ITEM FOR ENVIRONMENTAL COMMISSION AGENDA

COMMISSION MEETING DATE REQUESTED:	November 7, 2018
NAME & NUMBER OF PROJECT:	Pilot Knob 30-Inch Regional Wastewater Interceptor, Phase 2B SP-2018-0062D
NAME OF APPLICANT OR ORGANIZATION:	Daniel Dow Lockwood, Andrews & Newman, Inc.
LOCATION:	8113 ½ Dee Gabriel Collins Rd
COUNCIL DISTRICT:	Primarily located in Austin 2-mile Extra-Territorial Jurisdiction (ETJ), with no council representation; partially located in District Two.
PROJECT FILING DATE:	April 4, 2018
DSD/ENVIRONMENTAL STAFF:	Pamela Abee-Taulli, Environmental Review Specialist Senior 512-974-1879, pamela.abee-taulli@austintexas.gov
WATERSHED:	Cottonmouth Creek Watershed, Suburban, Desired Development Zone
ORDINANCE:	Watershed Protection Ordinance (current code)
REQUEST:	Variance request is as follows: 1. Request to vary from LDC 25-8-261 to allow construction of a maintenance access road for a wastewater utility line in the outer half of the critical water quality zone.

Development Services Department
Staff Recommendations Concerning Required Findings

Project:	Pilot Knob 30-Inch Regional Wastewater Interceptor, Phase 2B
Ordinance Standard:	Watershed Protection Ordinance
Variance

Exhibit A
Wastewater Interceptor Alignment

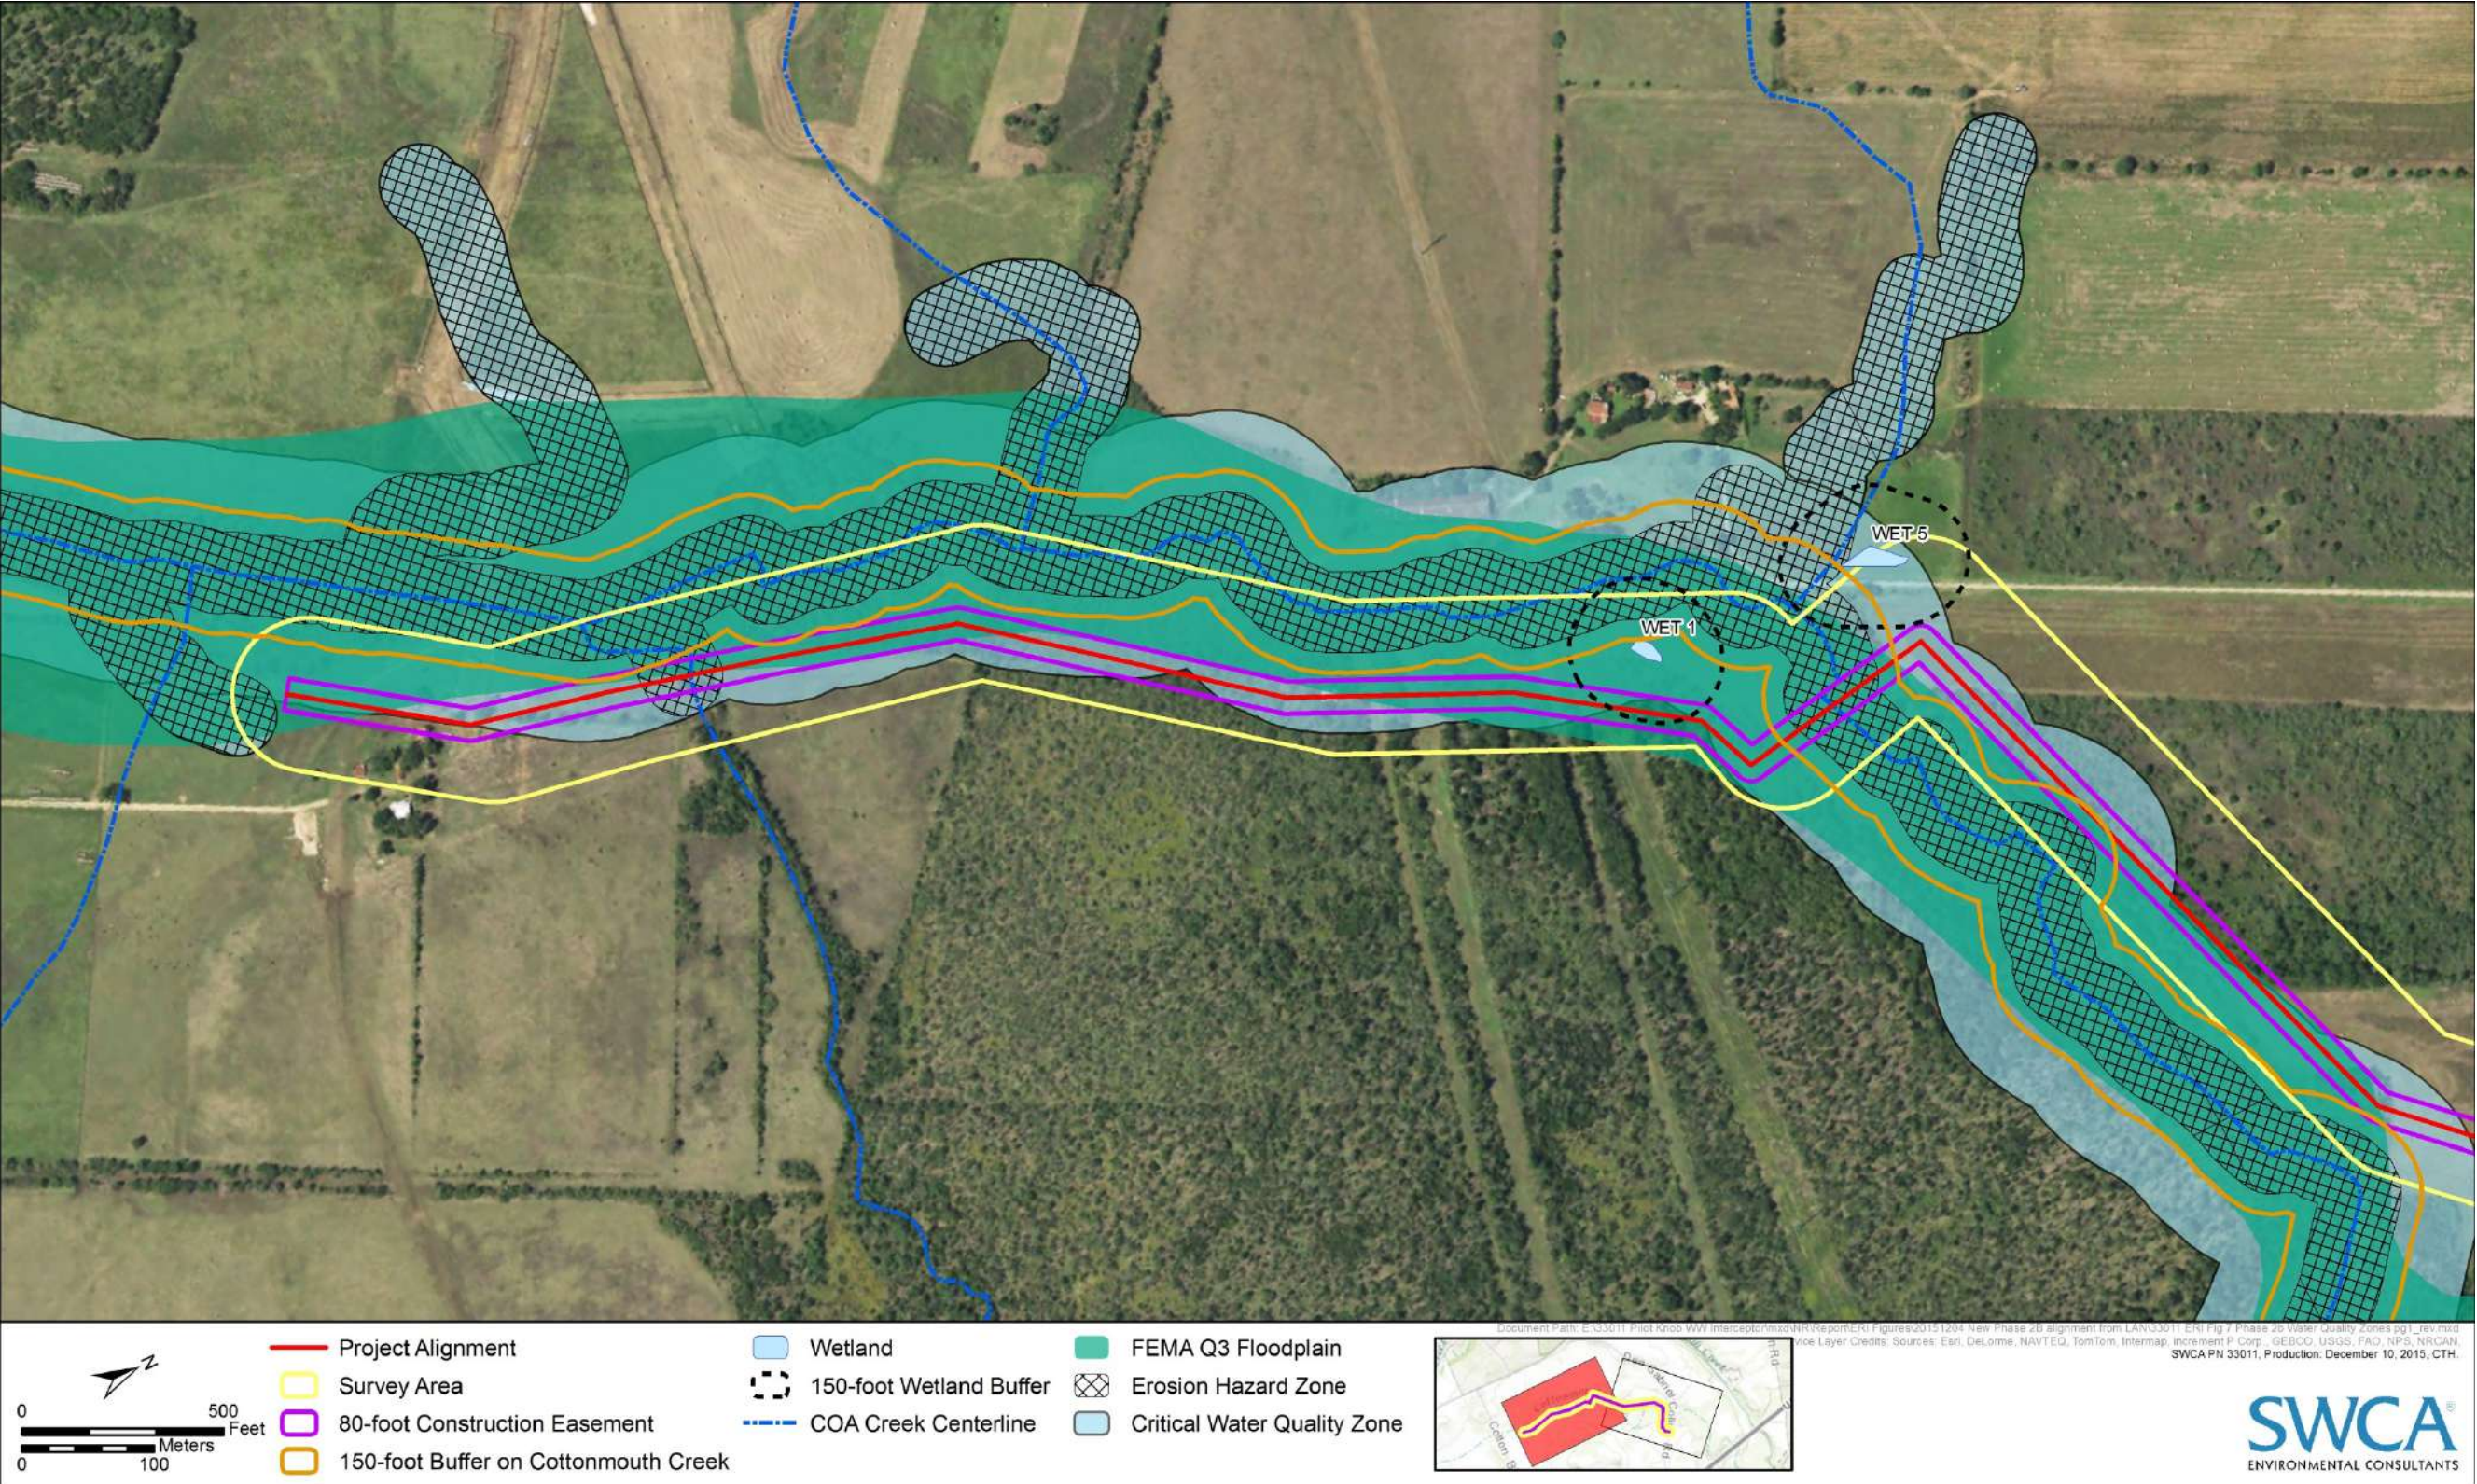
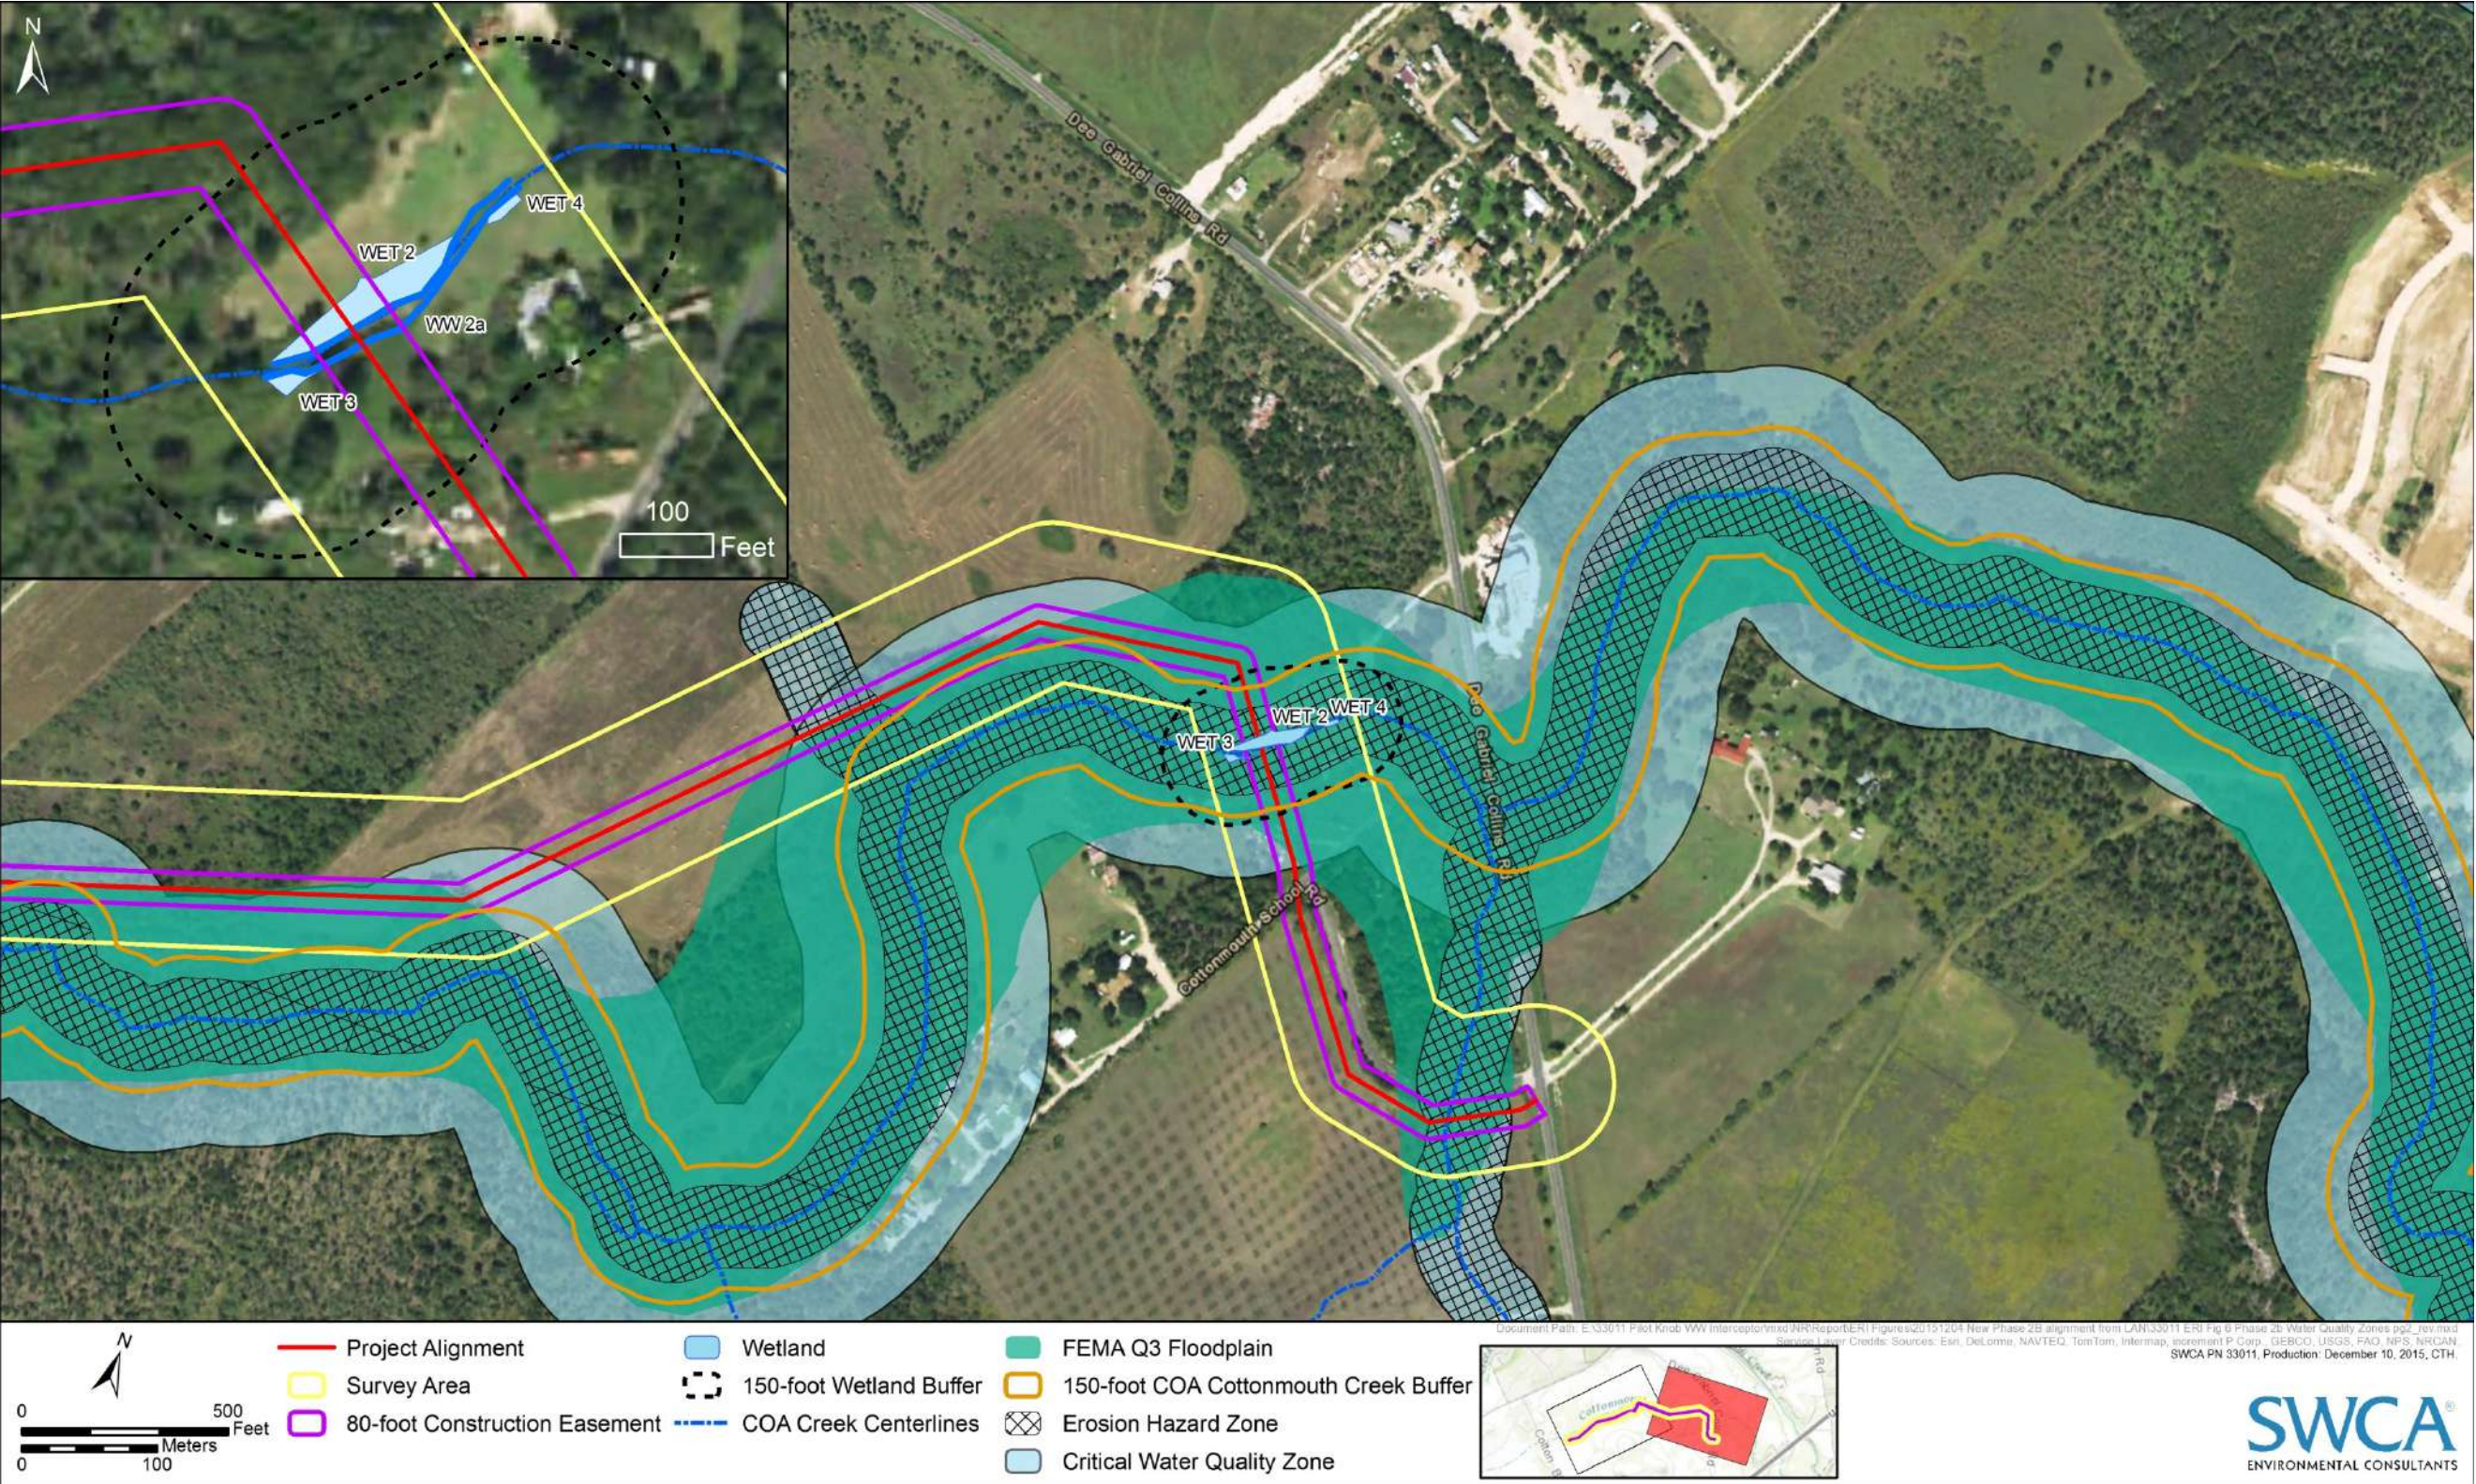
No The prohibition against development in a critical water quality zone (CWQZ), except as allowed in 25-8-261 of the Land Development Code (LDC), will not deprive the applicant of a privilege available to owners of similarly circumstanced properties. The variance is needed for development of service roads located parallel to and within the CWQZ, which has not been allowed in the past.

The proposed alignment for the wastewater line (see exhibit A) complies with LDC 25-8-261(E), which allows a utility line in a Suburban watershed to be located parallel to and within the critical water quality zone, if it is located not less than 150 feet from the centerline of a major waterway (the outer half of the CWQZ), and includes riparian restoration for an area equal in size to the area of disturbance.

However, the Austin Water Utility (AWU) requirement in Utility Criteria Manual (UCM) 2.9.4.D.1 states, "Manholes shall be located and spaced so as to facilitate inspection and maintenance of the wastewater main. All manholes must be

accessible to maintenance equipment, including 2½ ton straight trucks, dump trucks, vacuum trucks, and standard (not compact) sizes of backhoes and loaders. In isolated cases, construction of all-weather access roads may be necessary for manhole and/or wastewater line access.” AWU is requiring the applicant to construct an access road for infrastructure maintenance. In this case, the access road would have to be in the CWQZ. Hence, AWU criteria is in conflict with the LDC 25-8-261, which does not allow a road to be located parallel to and within the CWQZ.

While utility lines are allowed to be located within the CWQZ, roads are not. At the time that DSD was involved in negotiations with regard to alignment, AWU had not stated the requirement for an associated access road. Due to the width of the access easements, it is not possible to place the access roads both within the easements and outside of the CWQZ.

Yes The variance is necessitated by AWU requiring construction of an access road to maintain their infrastructure per UCM 2.9.4.D.1, not by a design decision made by the applicant.

No The minimum deviation from City development requirements that is necessary to allow reasonable use of the property is a waiver by AWU from the optional Utility Criteria Manual requirement for an access road. Deviation from the Land Development Code prohibition on development in the CWQZ is not necessary to allow reasonable use of the property.

No Development of a road in the CWQZ stream buffer would inhibit buffer function and therefore have a significant probability of harmful environmental consequences. The CWQZ stream buffer promotes healthy soils and vegetation along the creek corridor, allows the stream adequate space to migrate over time, helps control flood impacts, reduces channel erosion and property loss, maintains good water quality, reduces operation and maintenance costs, and provides multiple community benefits.

No Limited water quality controls (vegetative filter strips, rain gardens, biofiltration ponds, areas used for irrigation or infiltration of stormwater) are allowed in the outer half of a CWQZ in a Suburban watershed if they are outside the 100-year floodplain and comply with Drainage Criteria Manual requirements relating to the erosion hazard zone (LDC 25-8-261(H)). Due to the limited area of the easements, it is not possible to provide water quality controls for the proposed access road.
